Commonwealth Edison
 One First National Plaza, Chicago, Illinois
 Address Reply to: Post Office Box 767
 Chicago, Illinois 60690

Subject: Dresden Station Unit 3 Proposed Amendment to Facility Operating License DPR-25 and Dresden Station Special Report No. 40, Supplement A, NRC Docket No. 50-249

SPECIAL REPORT NO. 40

SUPPLEMENT A

Figure 3.5.1-1

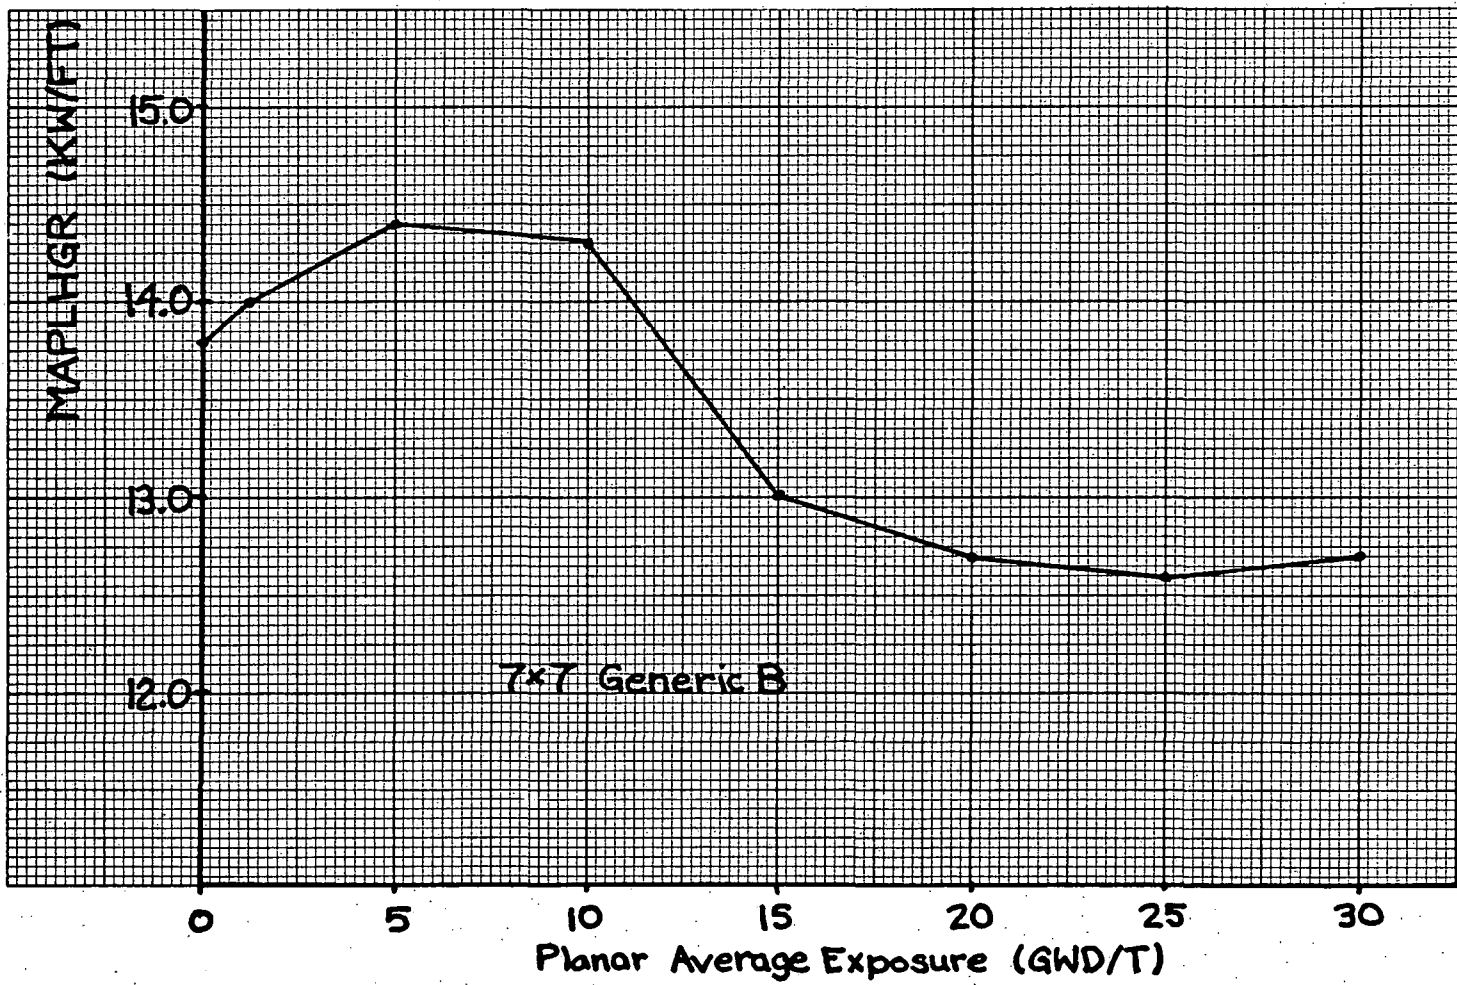
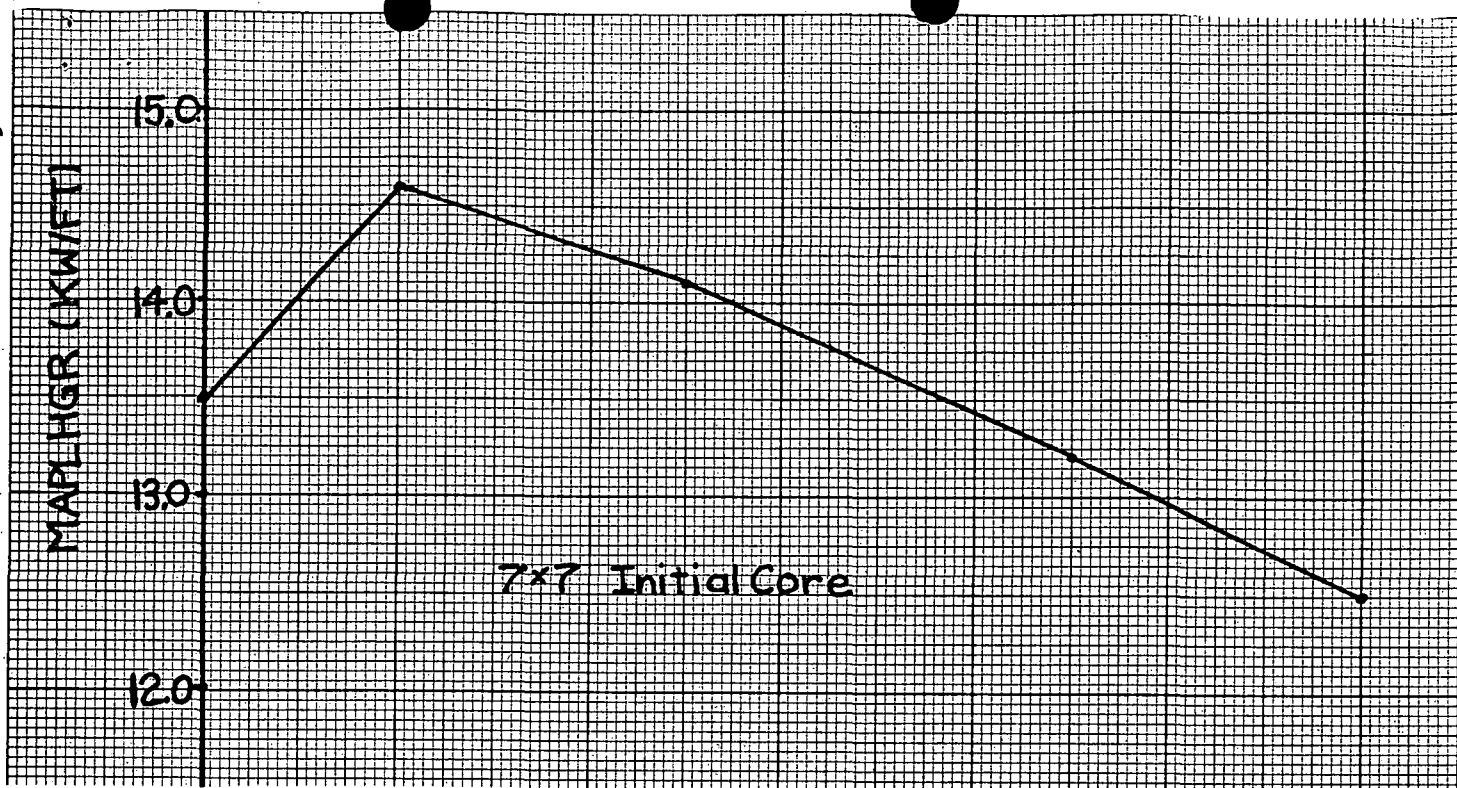
During steady state power operation, the average linear heat generation rate (LHGR) of all the rods in any fuel assembly, as a function of average planar exposure, at any axial location, shall not exceed the maximum average planar LHGR shown in Figure 3.5.1. If at any time during steady state power operation, it is determined that the limiting value for the average planar LHGR is being exceeded, action shall be taken to restore operation to within the prescribed limits.

The maximum average planar LHGRs shown in Figure 3.5.1 are based on calculations employing the models described in Reference (1). Power operation with LHGRs at or below those shown in Fig. 3.5.1 assures that the peak cladding temperature following a postulated loss-of-coolant accident will not exceed the 2200°C limit. These values represent limits for operation to ensure conformance with 10CFR50 and Appendix K only if they are more limiting than other design parameters.

The maximum average planar LHGRs plotted in Fig. 3.5.1 at higher exposures result in a calculated peak clad temperature of less than 2200°F. However the maximum average planar LHGRs are shown on Fig. 3.5.1 as limits because conformance calculations have not been performed to justify operation at LHGRs in excess of those shown.
